METROPOLITAN GOVERNMENT OF NASHVILLE AND DAVIDSON COUNTY

STAFF RECOMMENDATION 1410 Lillian Street November 19, 2014

Application: New construction-infill
District: Lockeland Springs-East End Neighborhood Conservation Zoning Overlay
Council District: 06
Map and Parcel Number: 08313032600
Applicant: Van Pond, Jr.
Project Lead: Paul Hoffman, paul.hoffman@nashville.gov

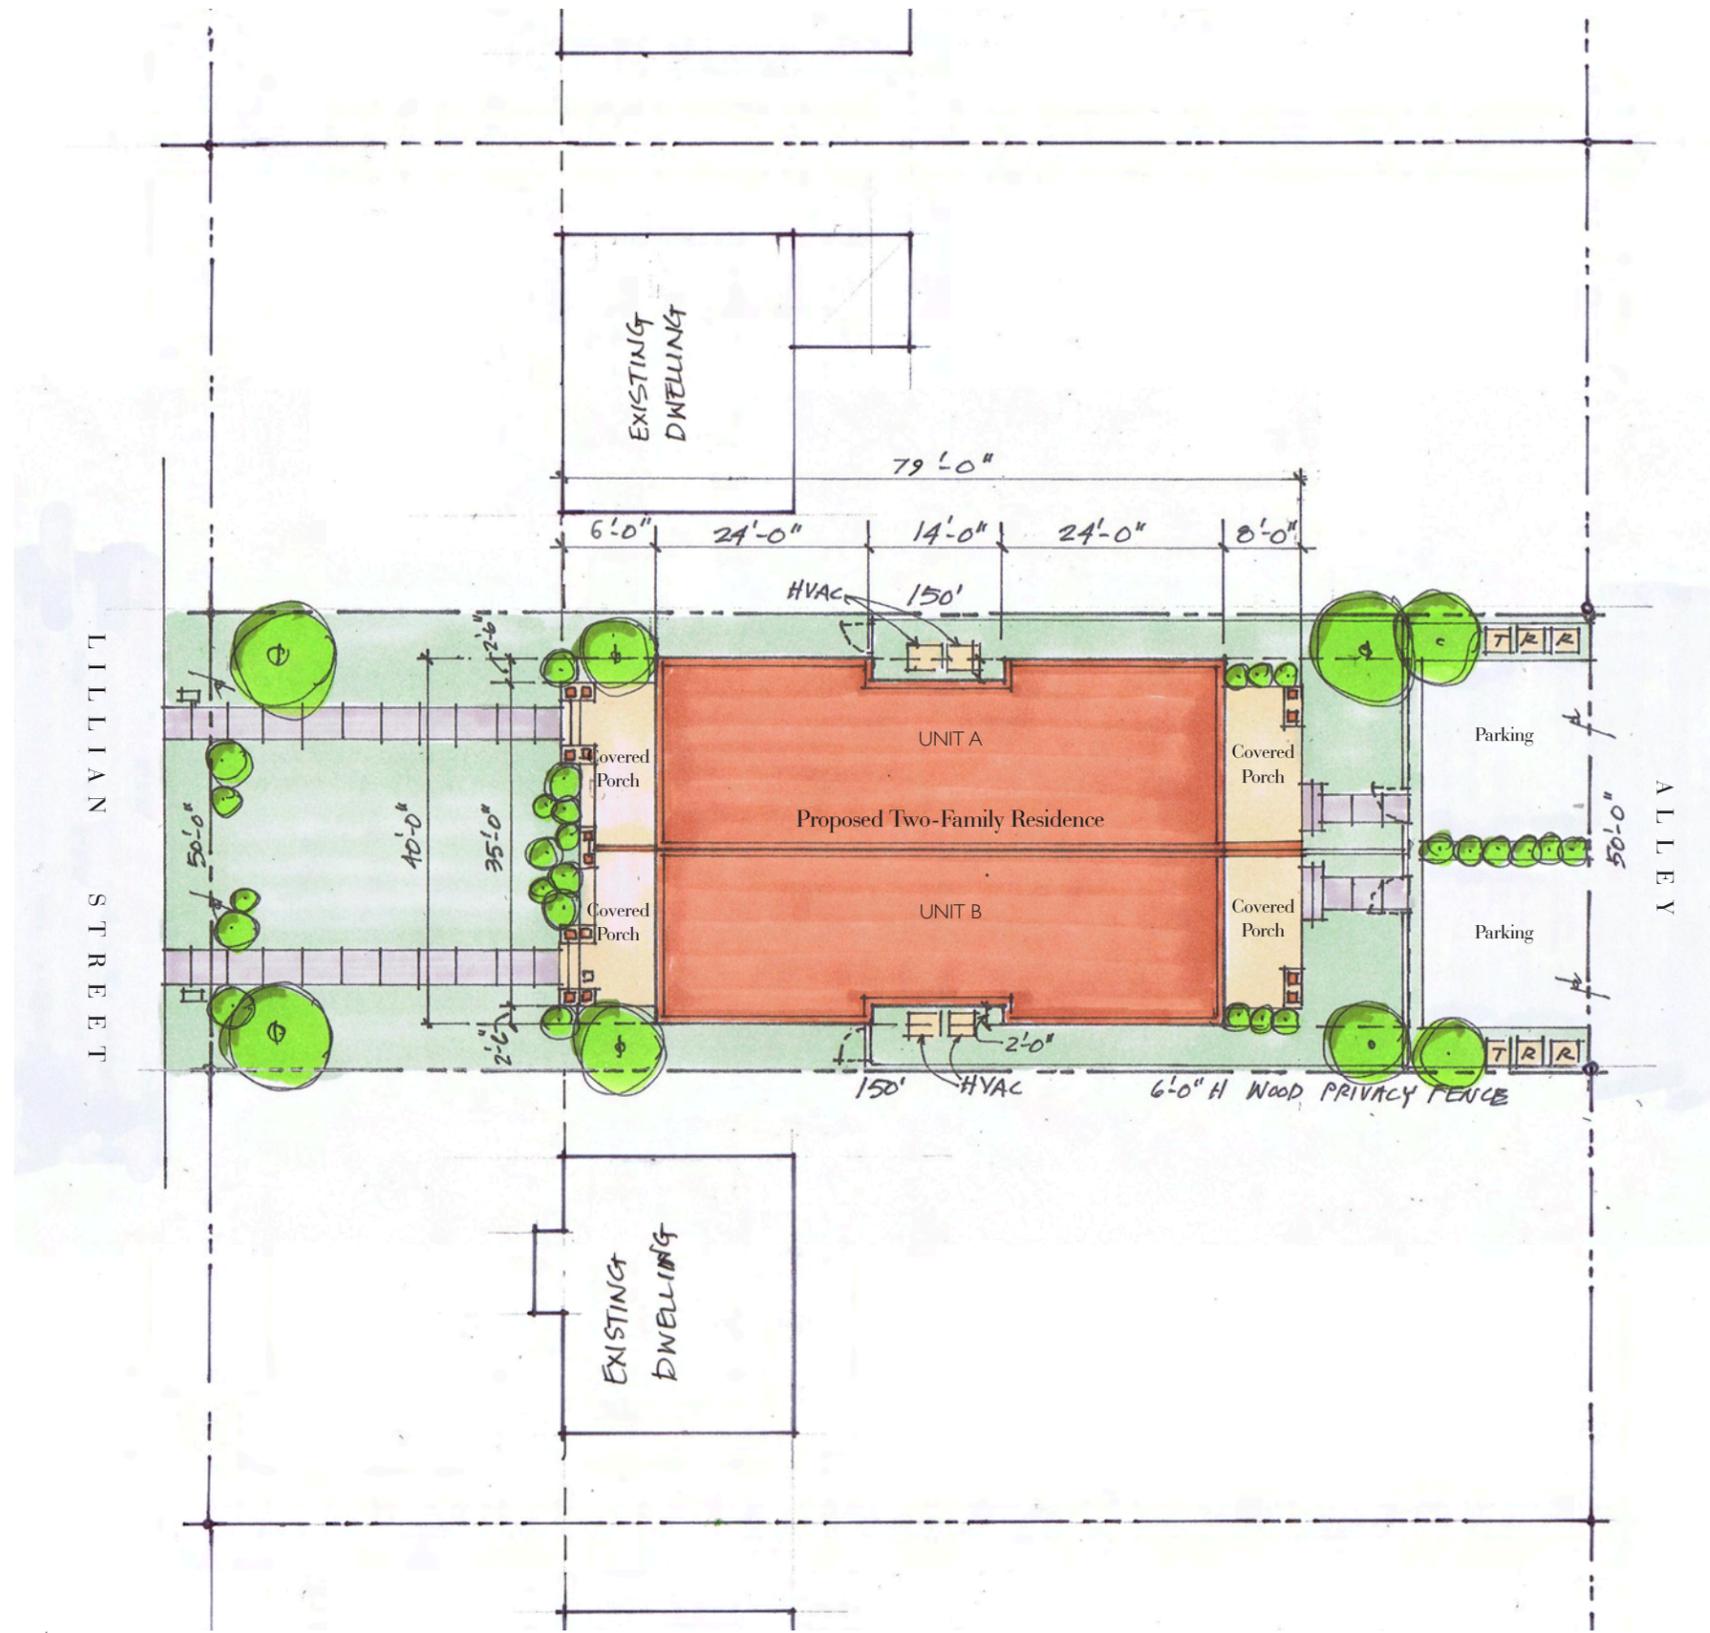
The building is proposed to be forty feet (40') in width. This is wider than the widest homes in the context by approximately four feet (4'). Although the historic context of this stretch of Lillian Street is not as strong as in other parts of Lockeland Springs; the nearby buildings are non-contributing homes built after 1950, or larger homes built within the last two years. Because the immediate context is minimal, staff used recent construction as the contextual measure. The MHZC approved several new construction projects replacing non-contributing houses on Lillian Street in the last two years. These recent infill projects, at 1228, 1230, 1232, 1238, 1306 and 1314 Lillian Street, range in width from twenty-nine feet to thirty-six feet (29'-36'). Staff recommends the width of the building be brought to no more than thirty-six feet (36') to be compatible with recent approvals. The scale would not contrast greatly with the scale of historic houses in the overlay. With this condition, the project meets section II.B.1. and 2.

Setback & Rhythm of Spacing: The proposed building will be centered on the lot, five feet (5') from the side property lines and forty feet (40') from the rear, meeting base setback requirements of five feet (5') and twenty feet (20') respectively. The front of the covered porches is in line with the street setback of the existing buildings adjacent. Although the project meets minimum setback requirements, typically houses in the vicinity have greater side setbacks. With the condition on reducing the width of the building (under the section on Height & Scale above), the side setbacks will be increased two feet (2') on each side to be more in keeping with the surrounding historic context. Staff finds the project meets section II.B.3.

1. The width be reduced to thirty-six feet (36') to be compatible with recently-approved infill;
2. The finished floor height shall be consistent with the finished floor heights of the adjacent historic houses, to be verified by MHZC staff in the field;
3. Staff approve the final details, dimensions and materials of windows and doors prior to purchase and installation; and,
4. Staff approve the roof color and masonry color, dimensions and texture.

Proposed Roof Plan
 1/8" = 1'-0"

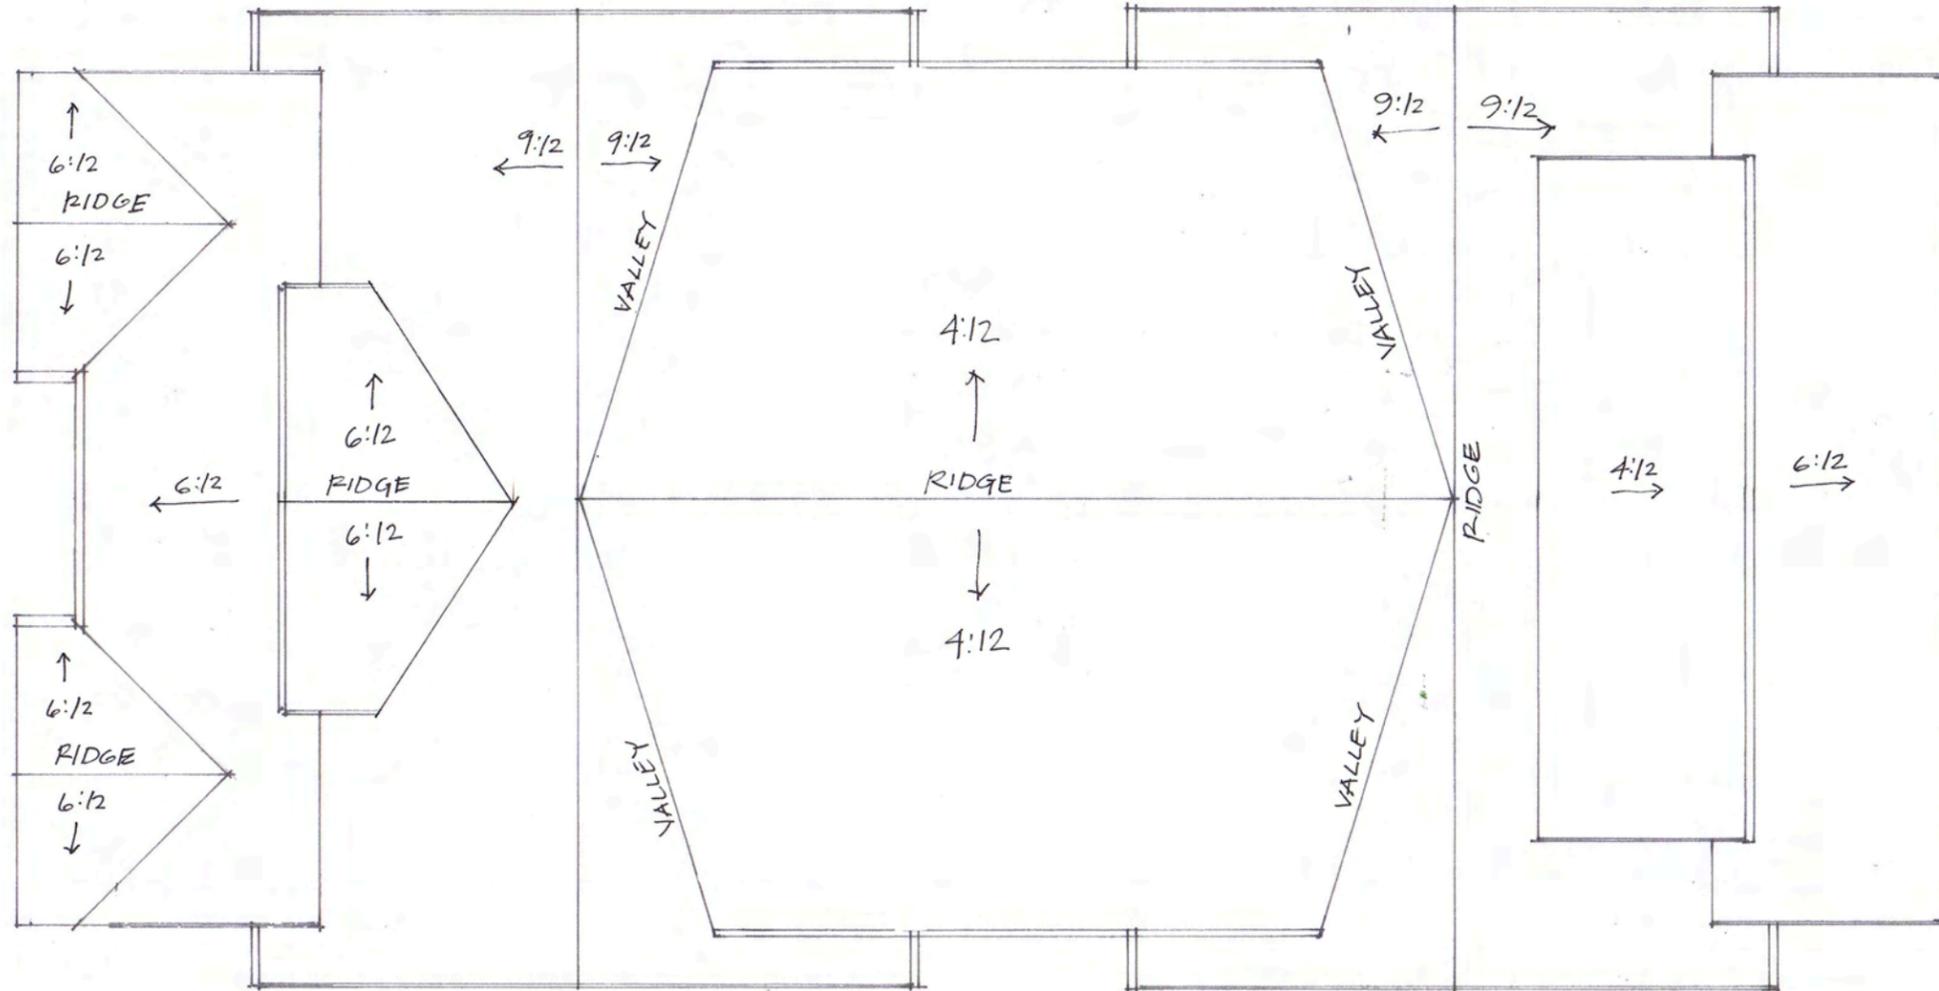
Roof form: The side-gabled portions of the roof have 9/12 pitch; the connecting portion between is 4/12. Gabled dormers are 6/12, and rear-facing shed dormer is 4/12. The proposed roof shape and pitches are compatible with the historic context. The project meets section II.B.5.

Proposed Street (North) Elevation
 1/8"=1'-0"

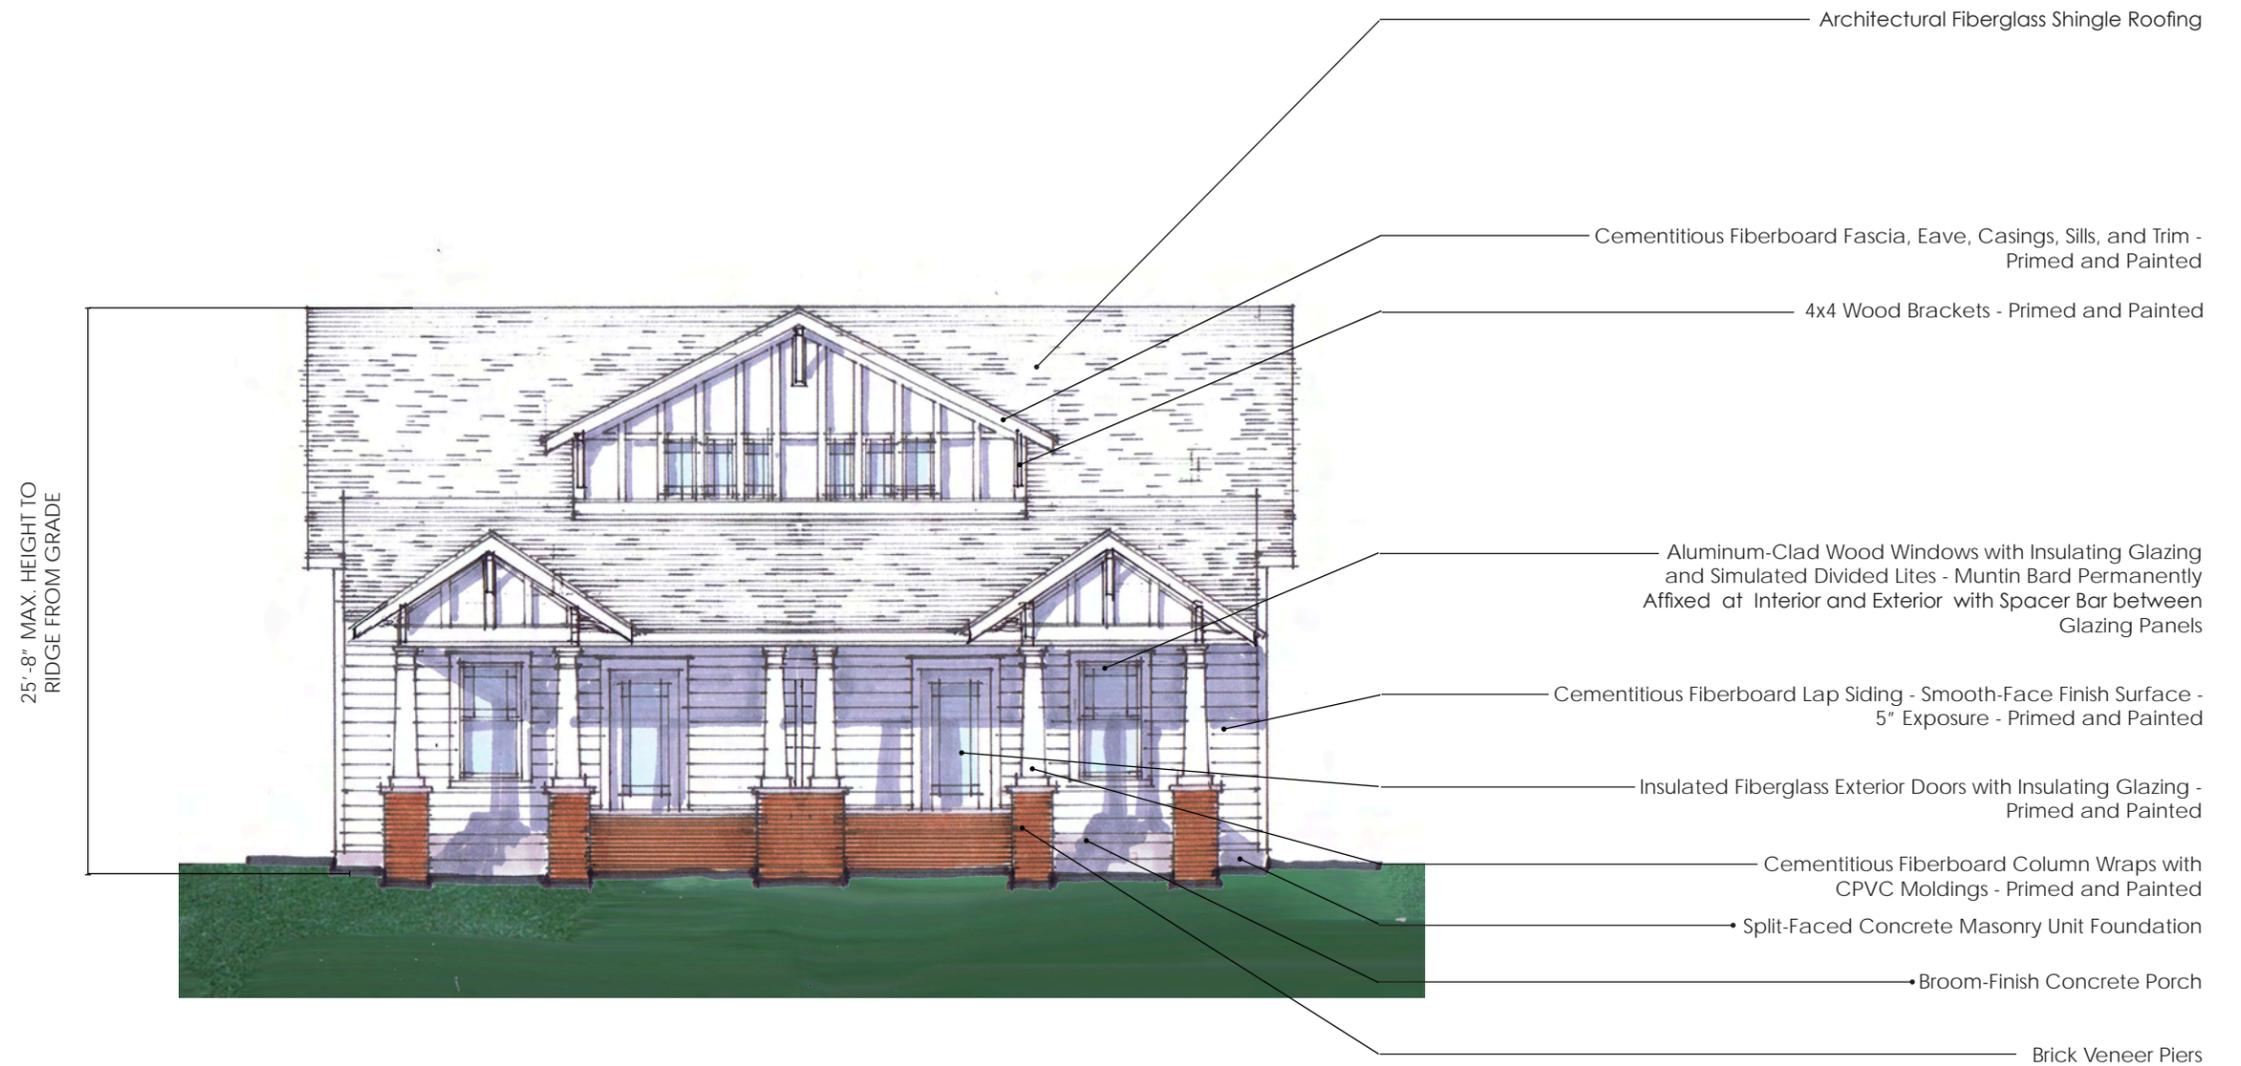
Materials: The infill will have fiber cement lap siding with a five inch (5") reveal. Foundation will be split-face concrete block. The roof will be architectural fiberglass shingles; Staff requests final approval of the color of the roofing. Trim will be wood or fiber cement. The porch will have a concrete floor, brick veneer piers, and fiber cement columns. With the staff's final approval of the roofing color, masonry, windows and doors, staff finds that the known materials meet section II.B.4.

Proportion and Rhythm of Openings: The windows on the proposed are generally twice as tall as they are wide, meeting the historic proportion of openings. There are no large expanses of wall space without a window or door opening. Staff finds the project's proportion and rhythm of openings to meet Section II.B.7.
